# Front Range Midway Solar Project - Key Observation Point 1

# photo sim V\_1 Attmnt 27 redlines.pdf Markup Summary 7-28-2020

# Front Range Midway Solar Project - Key Observation Point 2

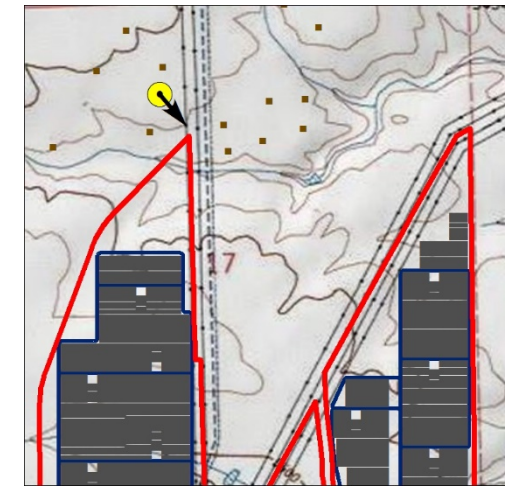
what is the distance from this house to site arrays?

what is the distance from this house to site arrays?

# Front Range Midway Solar Project - Key Observation Point 5

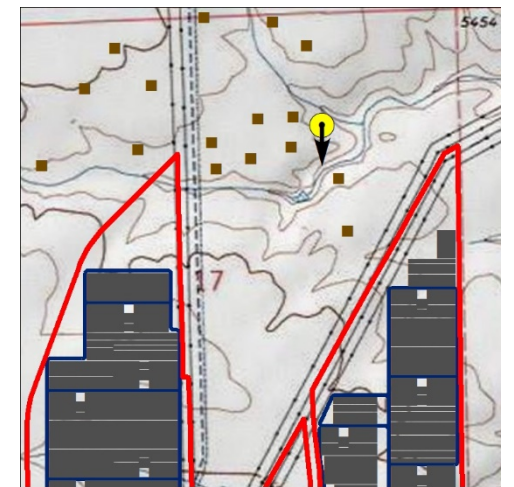
add the substation and new buildings since your proposing o double the height to one view please.

there are lots to the north provide a visual from there please

add the substation and new buildings since your proposing o double the height to one view please.

there are lots to the north provide a visual from there please
